Swanwick Airspace Improvement Programme
Airspace Development 3
LAC S21/ Jersey/ Brest Interface

SAIP AD3
Gateway documentation:
Stage 3 Consult

Step 3D Collate and Review Responses

Figure 1: Consultation responses to themed questions

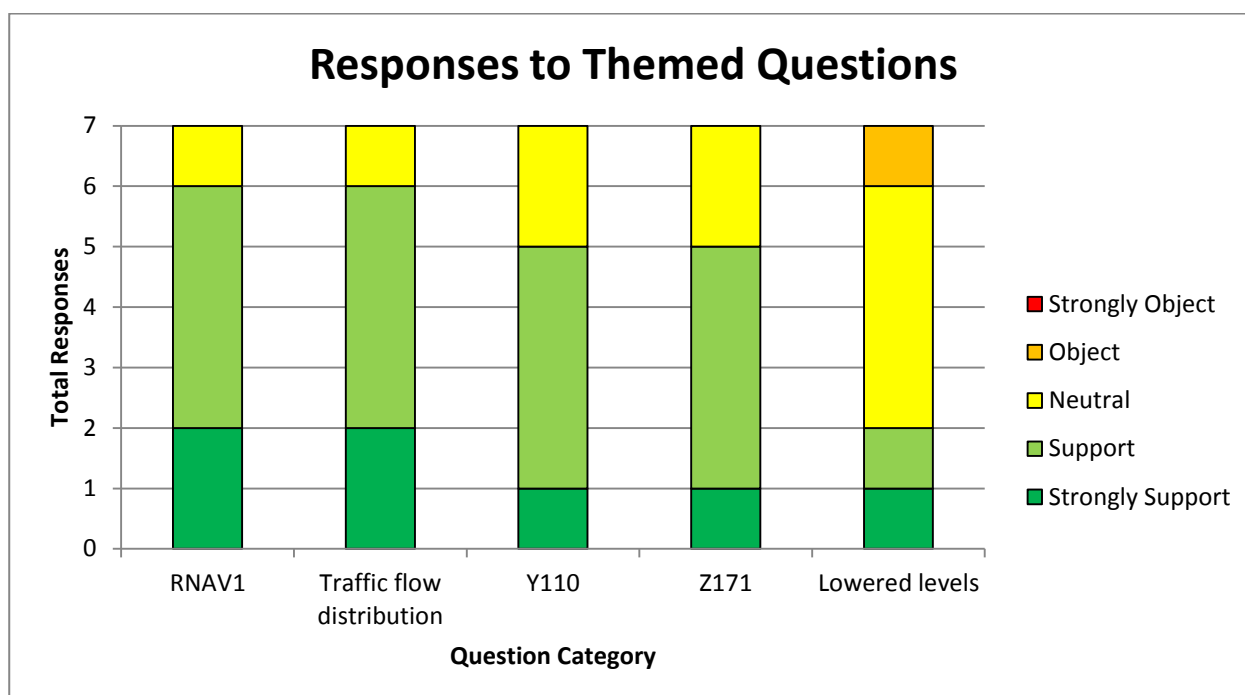
- 3.8 As seen above, the majority of respondents showed support for the specific elements of the proposal with 69% of all responses either strongly supporting or supporting. There were 10 neutral responses received (29%) and one which objected to the lowered levels (3%). This is covered in more detail in Section 4 below.
